UNITED STATES  
**NUCLEAR REGULATORY COMMISSION**

URFO:DLJ  
 Docket No. 40-8905  
 SUA-1473, Amendment No. 18  
 040089051300  
 04008905132E  
 04008905133E  
 04008905135E

MEMORANDUM FOR: Docket File No. 40-8905

SUBJECT: AMENDMENT NO. 18 TO SOURCE MATERIAL LICENSE SUA-1473:  
 RECLAMATION AND CLOSURE OF QUIVIRA'S AMBROSIA LAKE MILL  
 DISPOSAL AREA NEAR GRANTS, NEW MEXICO

AMBROSIA LAKE MILL  
RECLAMATION PLAN

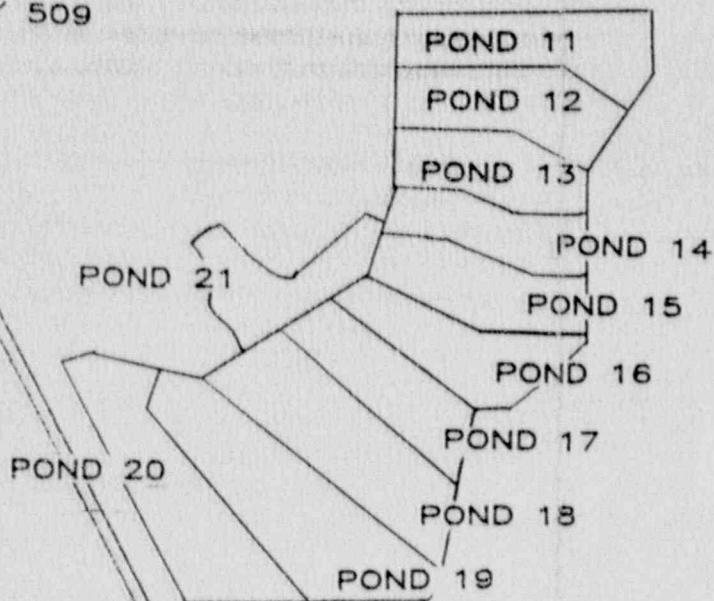
Although not currently considered part of the disposal area, a sudden release of water impounded by the fresh water dam (Figure 1) located upstream of the disposal area would negatively affect the integrity of the downstream toe of Pond 1. Therefore, as the stability of this structure has not been substantiated, the licensee will be required to breach the dam prior to final reclamation of the facility. Alternatively, the licensee may submit the necessary stability analyses for the dam to NRC for review and approval.

Figure 2

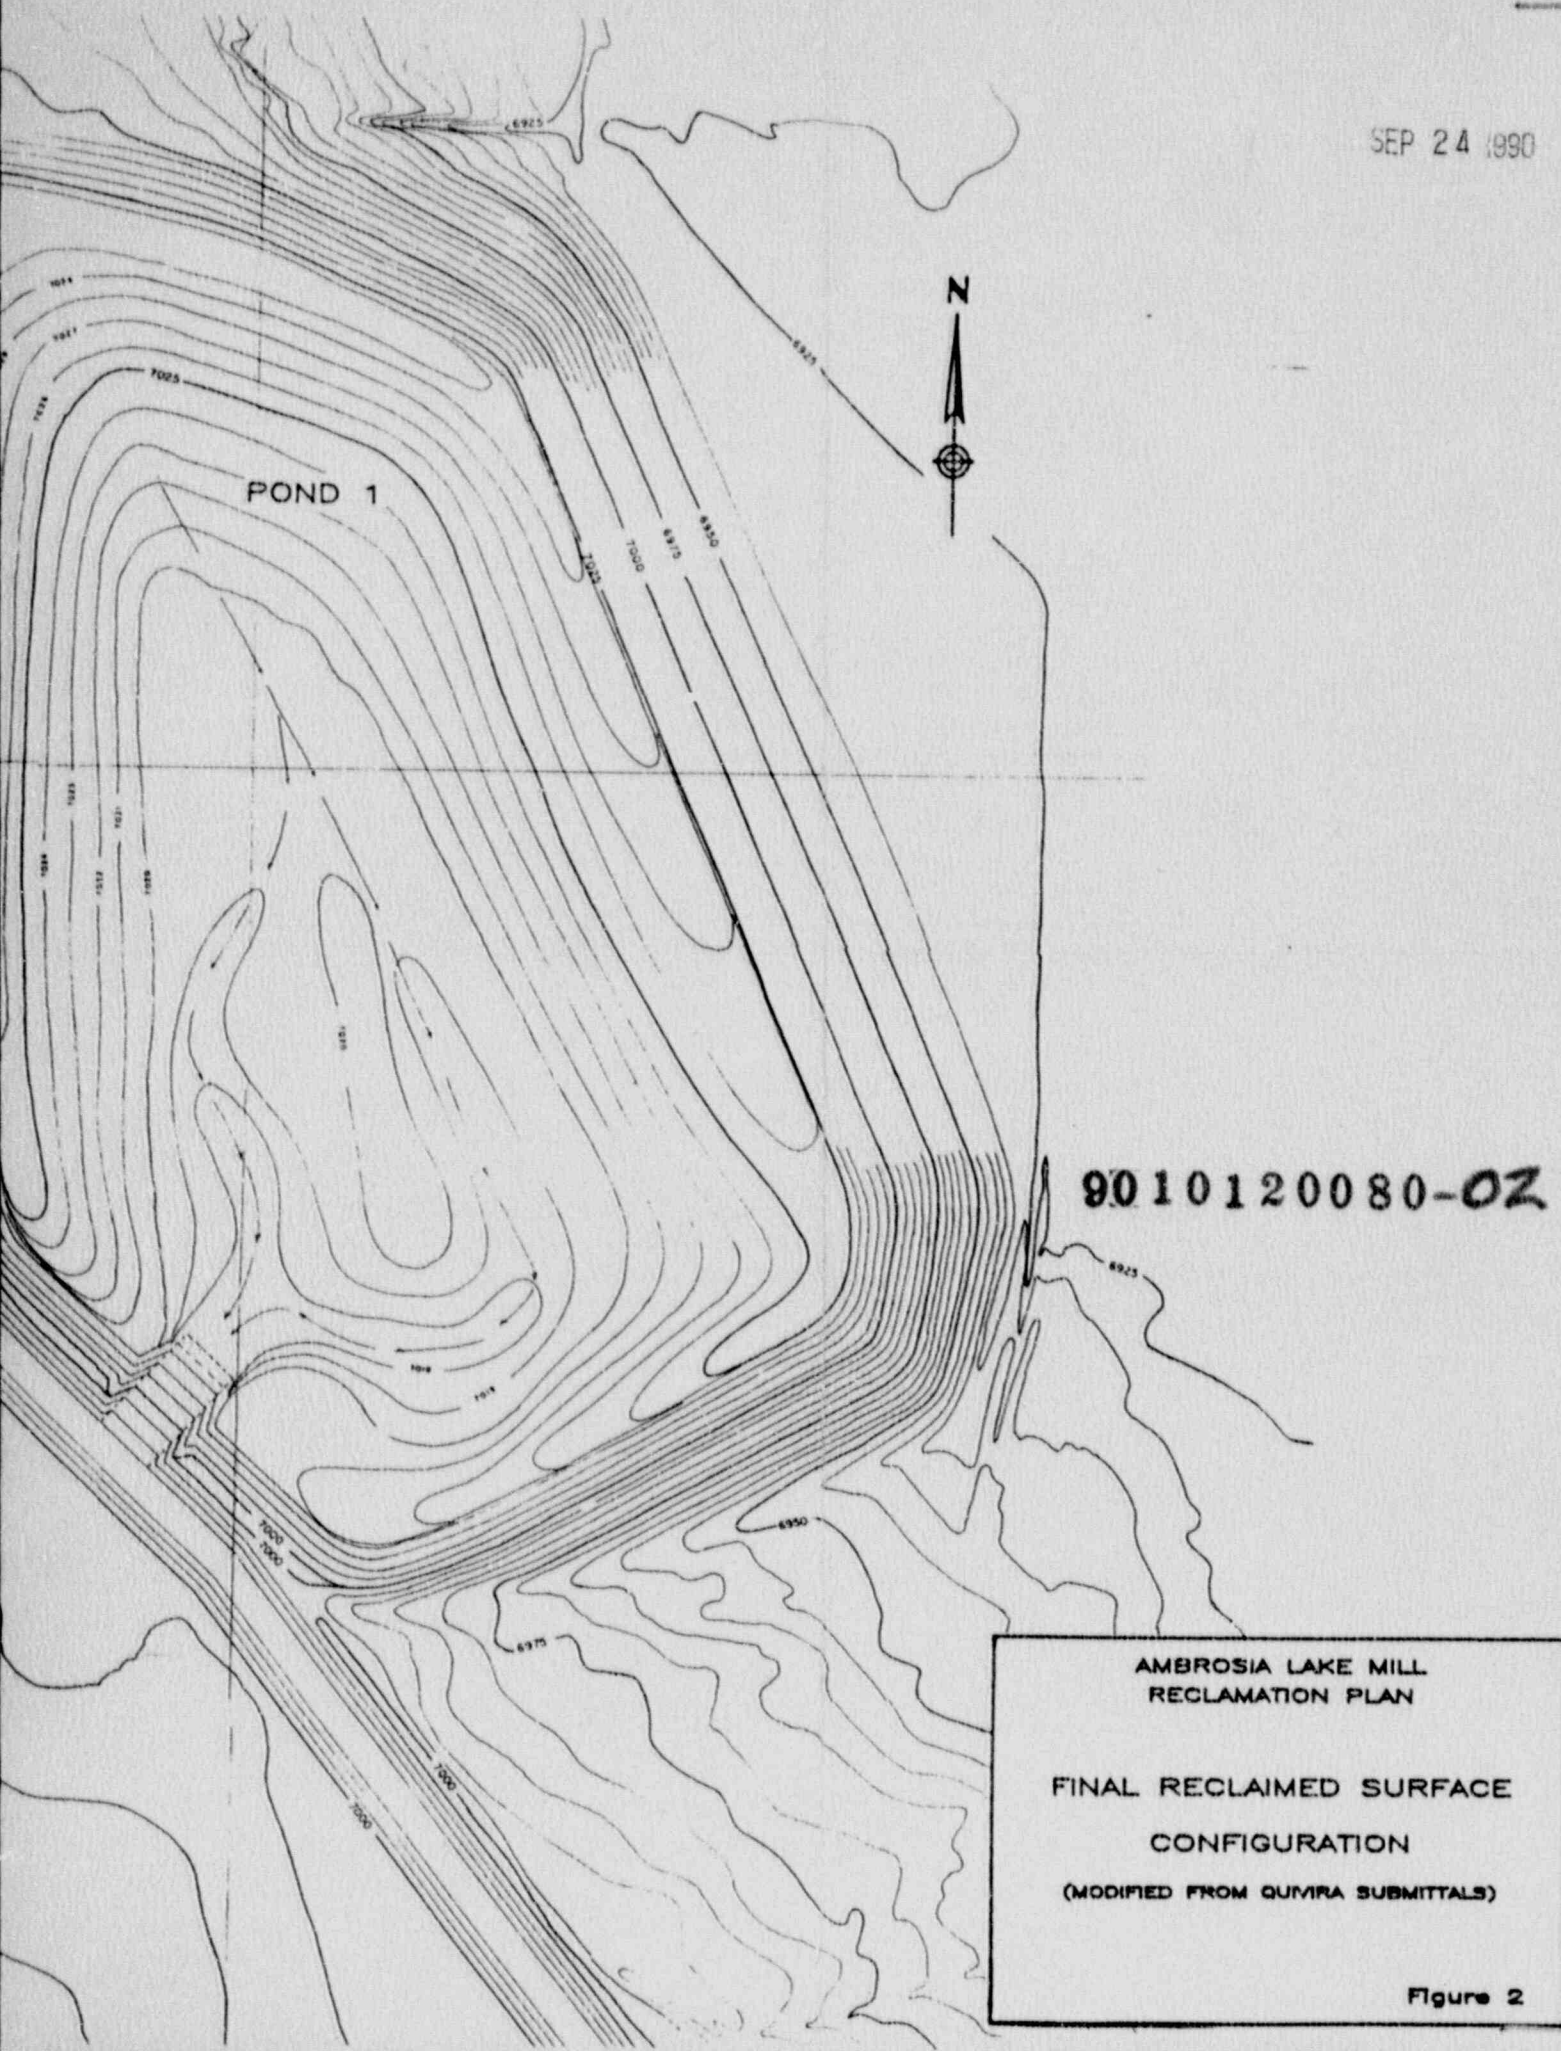
As shown in Figure 2, Ponds 1 and 2 will be reclaimed in place. The top of Pond 1 will be provided with very flat slopes which will drain from north to south. A riprapped spillway on the south side will convey flood flows off the pile top into the South Diversion Ditch. The Pond 1 side slopes will be reduced to 20 percent (5H:1V) and will be protected against erosion with a layer of riprap.

As shown on Figure 2, the tailings pile is located on the southwestern side of the valley of Arroyo del Puerto. The alluvial valley in this area is about 1 mile wide. The pile is underlain by unconsolidated materials associated with small tributaries to the arroyo, and weathered and unweathered sandstone and shale. The arroyo is located along the northeastern side of the tailings pile. It is incised, naturally and artificially, up to about 20 feet deep. Observations along the entire reach below the pile indicate that bedrock forms the channel bank on the southwestern side.

As shown on Figure 2 the top of Pond 1 will be graded to slope from north to south. Runoff from the pond will convey off the top to the South Diversion Ditch through a 200-foot wide spillway. The top of the pond will have two gently sloping swales that will converge at the spillway. The slopes of these two swales will average about 0.001. The slopes of the areas draining into the swales will be about 0.01.

As shown on Figure 2, Pond 2 will be graded to drain into the South Diversion Ditch. The slopes of the reclaimed surface of the pond will be sufficiently flat to minimize the potential for excessive erosion.

the spillway on Pond 1. The licensee shall be required to extend the riprap 45 feet onto the flatter pond surface rather than their proposed 10 feet distance, and this riprap shall be placed over a 6-inch thick bedding layer of smaller rock. The riprap extension is necessary to assure that unacceptable erosion upstream of the spillway will not occur.
